ZTE CORPORATION**Product Change Description**

[Z791G]
[ZTE Corporation]

[Z791]
[ZTE Corporation]

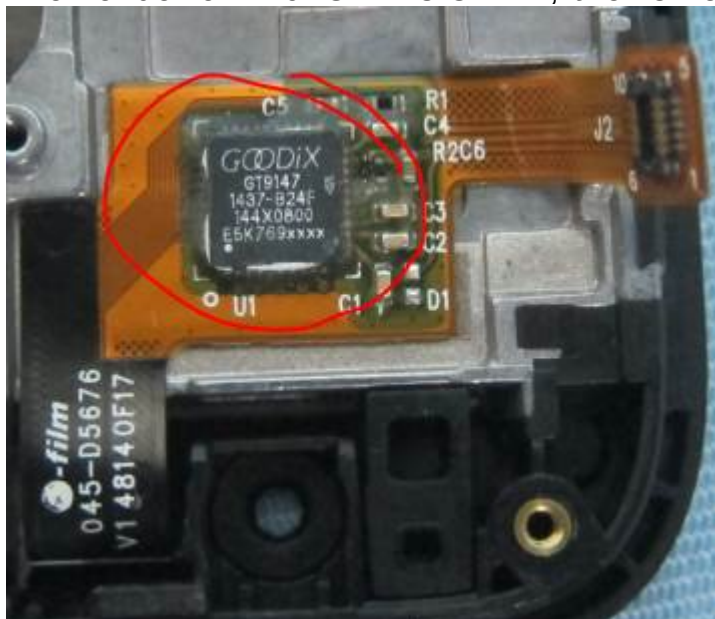
Other changes: Yes

The SIM card socket is changed from push-push type to push-pull type

The earphone jack is changed from 13.1X6.6X4.55mm to 8.7*12.66*4.2mm
